RE: DSRFY2025-0008

I have reviewed the application for a design review for a new 236-dwelling unit multi-family residential development at 8647 & 8687 W. Marigold Street and offer the following comments:

Figure 2: Warm Springs Canal in vicinity of project area

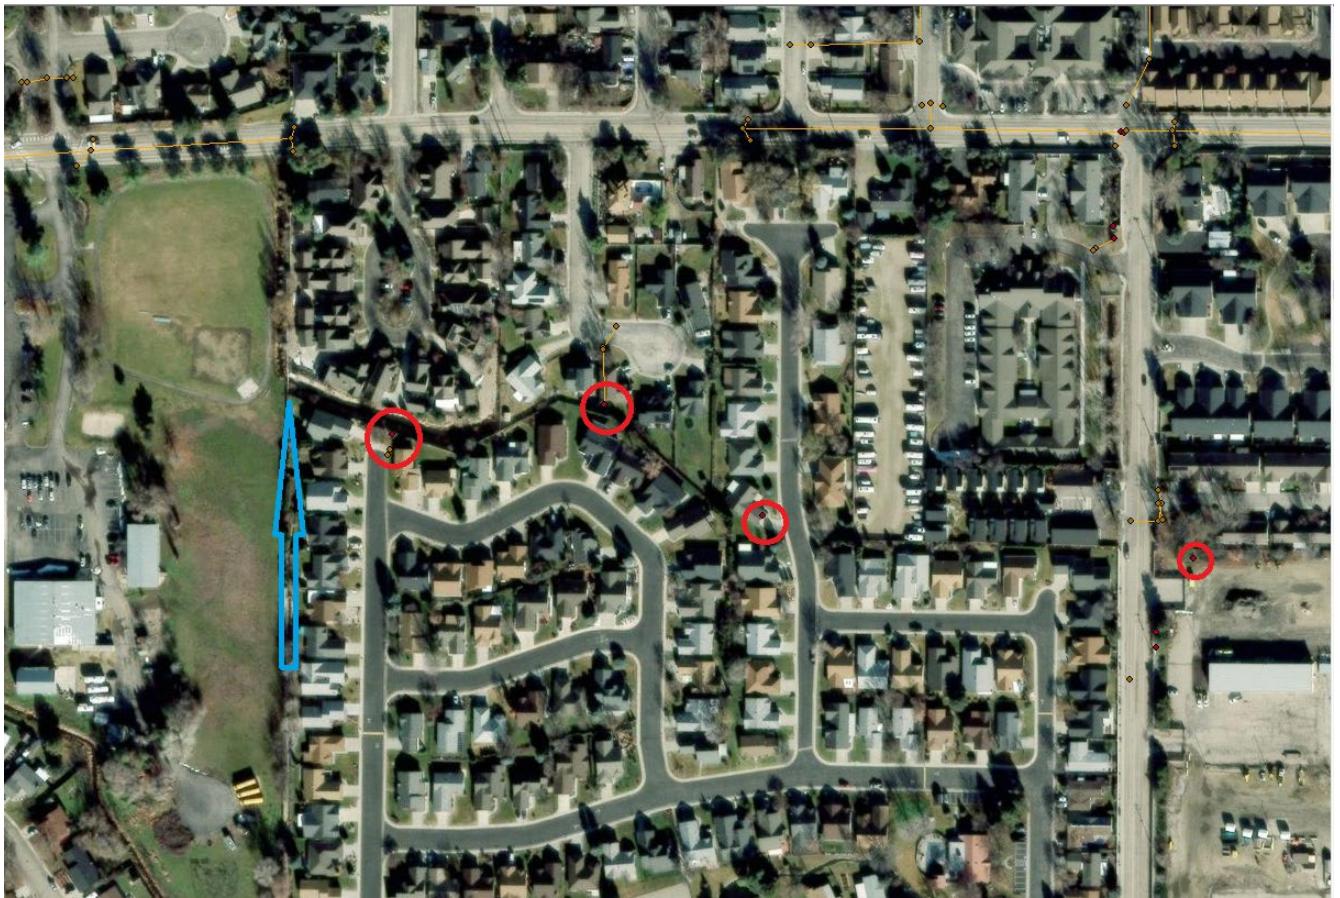
Outfall pipes filling the canal during storm events have been circled in red. A separate pipe, not in the ACHD Stormwater data, is shown as a blue arrow running south to north along the west side of Willowbrook Estates #3. Figure 3 illustrates the outfall and was a photo taken looking south while standing on the southwestern corner of the Bentwood Subdivision.

The outfall of this pipe into the Warm Springs Canal is called a hydraulic junction. The intended piping of the Warm Springs Canal moves the current hydraulic junction from the vicinity of Marigold Street to the vicinity of the Figure 3 outfall (hydraulic junction). The applicant has not presented any hydraulic study stamped and signed by a professional licensed engineer in the State of Idaho to explain the effects of a 100-year storm event at

these hydraulic junctions. Currently, if the pipe adjacent to Marigold Street is topped by water flow, and then tops the ditch, the flow can go west into a softball field. If the water flow tops the pipe inlet at its new intended location, what is the effect on the neighboring developed properties?

Figure 4: Cover Sheet / Site Plan C1.0 clip of third access

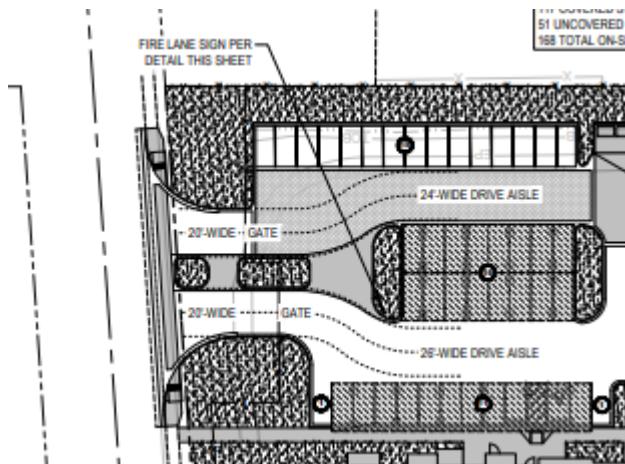
2. Agency Comment ACHD 06172025 states on page 8, in section 5.1.c. that “. . . applicant’s proposal to construct a third driveway onto Marigold Road for this site does not meet District Access Management and Driveway Width policies . . . and should not be approved as proposed.” This seems to be acknowledged on applicant package page 18, also identified as page A-1, that shows an uninterrupted metal fence line at this location. However, the Cover Sheet / Site Plan C1.0, applicant package page 32, does not identify this as an emergency fire only access, see Figure 4, below, clipped from that sheet:

Request this to be provided with the same level of detail as is found in Figure 5, the widened pathway to Build 2 on the same sheet. Specifically, “EMERGENCY VEHICLE ACCESS” annotation.
